December 5, 2018

Re: Traffic Signal Issues at King Edward Ave. and Arbutus St.

Figure 1 - Arbutus St and King Edward Avenue showing conflict paths with east crosswalk

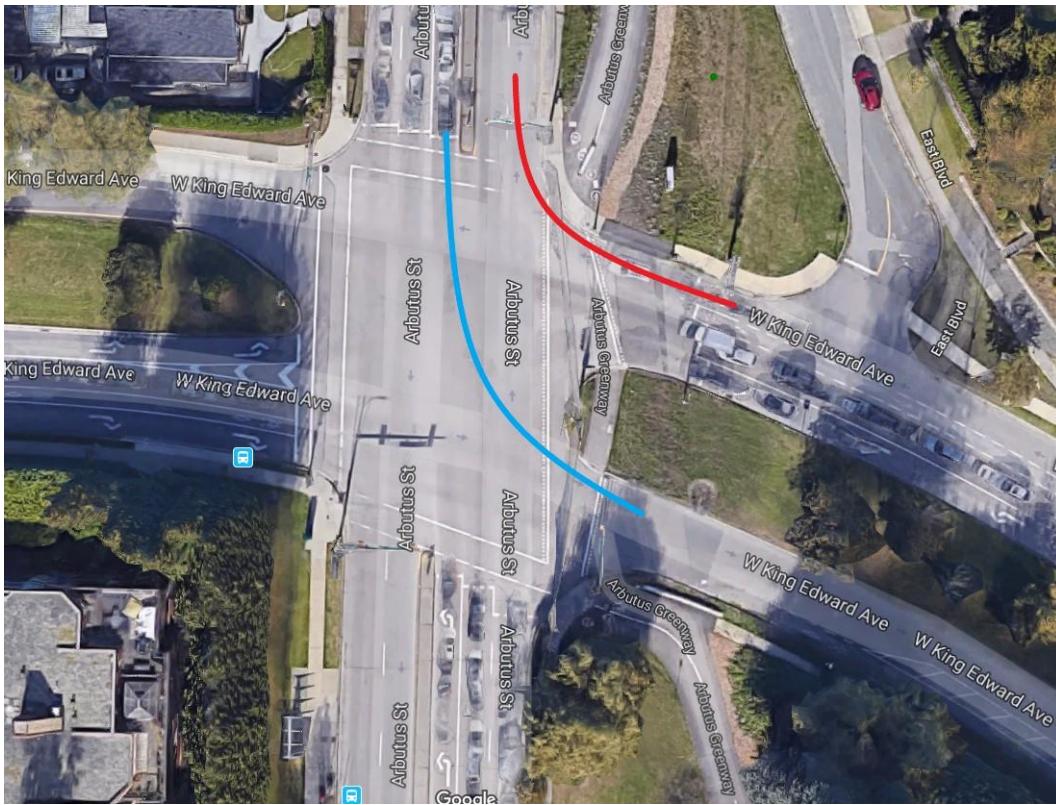
- 1) Vehicles travelling south on Arbutus and turning left onto King Edward present conflicts with users of the east crosswalk and cross bike. (Conflict 1, blue line on Figure 1)
- 2) Vehicles travelling west on King Edward and turning right onto Arbutus present conflicts with users of the east crosswalk and cross bike (Conflict 2, red line on Figure 1)

Vehicle operators travelling south on Arbutus and turning left onto King Edward have an advance green. This signal remains solid green (for straight through traffic, not turning movements) when the crosswalk signal changes to permit people walking and people on bikes to cross King Edward. Drivers have on numerous occasions narrowly missed people in the east crosswalk, seemingly being focused more on looking for breaks in oncoming vehicle traffic to complete their turns. We note that Arbutus descends south of King Edward, so oncoming vehicles may not be as visible to left turning vehicles as if Arbutus was level. We recommend consideration of phased protection, with a red left turn arrow after the advance green arrow.

Vehicle operators travelling west on King Edward and turning right onto Arbutus are permitted to turn right on red, across the east crosswalk. They are often seemingly focused on southbound vehicle traffic on Arbutus, and are looking for an opening, instead of focusing on people in the east crosswalk. Vehicles are frequently observed making this turn without first stopping at the red light. In addition, the turn lane being positioned to the right of the bike lane makes this very uncomfortable for people on bikes stopped waiting to cross Arbutus. We recommend a no right turn on red rule here, and a clearer stop line set well back from the intersection.

- a) The crosswalk markings and stop lines are faded.
- b) The intersection is very wide.
- c) King Edward does not intersect Arbutus at a right angle, meaning that the two vehicle turning movements highlighted permit higher vehicle speeds. Conflicts have not been noted to the same extent for vehicles northbound on Arbutus and turning right across the crosswalk, possibly due to the slower speeds resulting from the acute angle of the two streets.

- d) The east crosswalk is not straight, but rather runs both east and west of the signal pole. This could lead to confusion because drivers may not expect pedestrians on the east section, where pedestrians and bikes can emerge from behind the signal pole.

- e) The push button for users to activate the east crosswalk signal, located on the north east corner of the intersection, is not positioned near the bike path. It is inconvenient to reach, and results in people waiting to cross being partially hidden by the curbside signal pole, for drivers in the curbside turning lane. It also means that some path users are not aware of the need to push the button, and so end up crossing without a crosswalk signal.
